SOILS EVALUATION

Record Number: [EHU-09-25-0918](#)

Project Address: LEWIS RIVER RD, WOODLAND, WA 98674

Site Evaluation & Soil Report For Lot 4 @ Parcel Number: EM2405010

Chilton Inc. Parcel Number: EM2405010 Ariel, Washington 98603	Advanced Septic Consulting Inc. 3210 Westside Hwy. Castle Rock, Washington 98611 Cell: 360-433-5476 E-Mail: dirtwhisperer@gmail.com	Design: 25-228.4	Date: 9/11/2025
		Drawing: 1	Scale: 1" = 60'

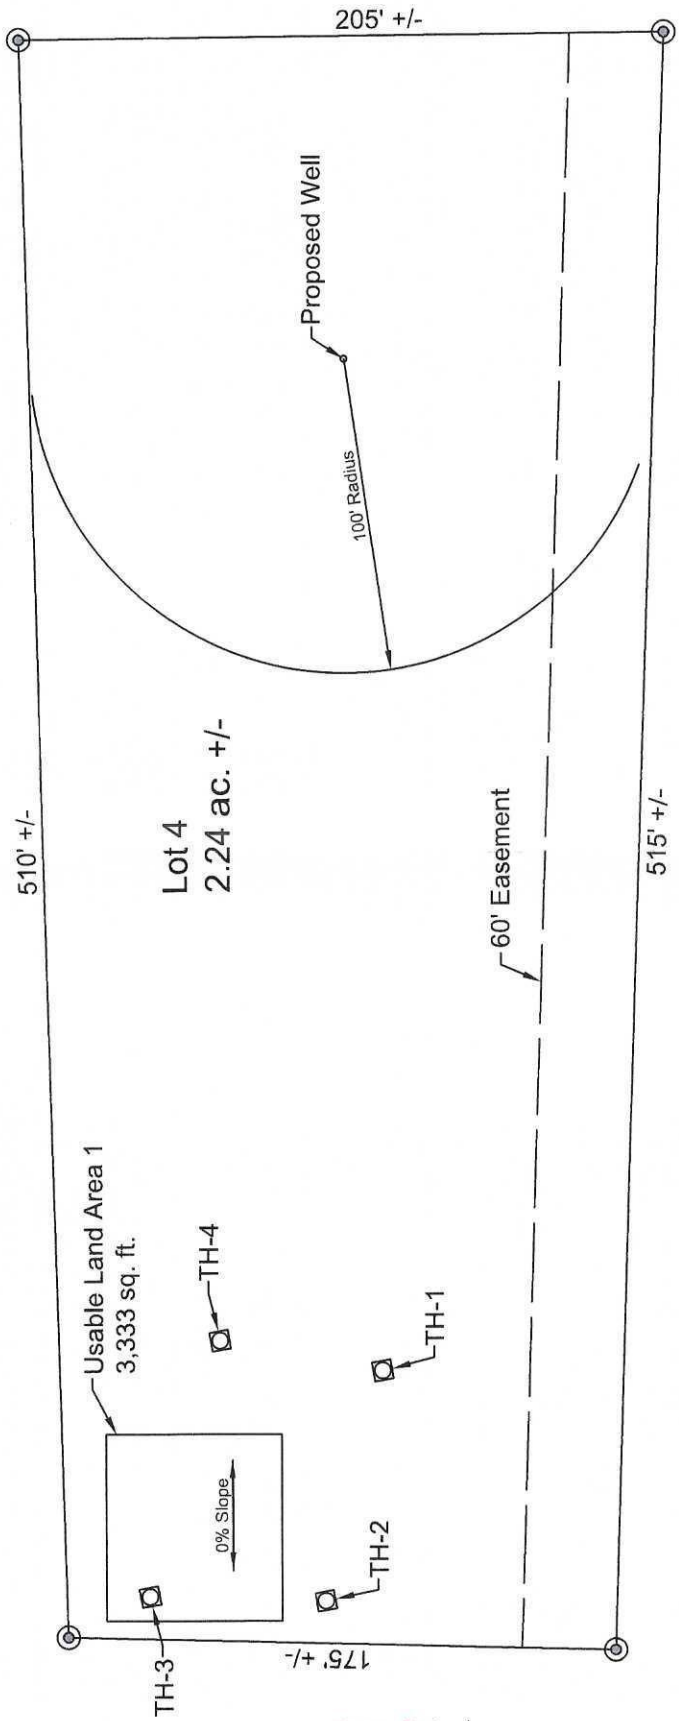
For future well construction: When drilled, the well must maintain a 100' setback from the approved, proposed primary and reserve septic areas or new test holes will need to be opened and evaluated.
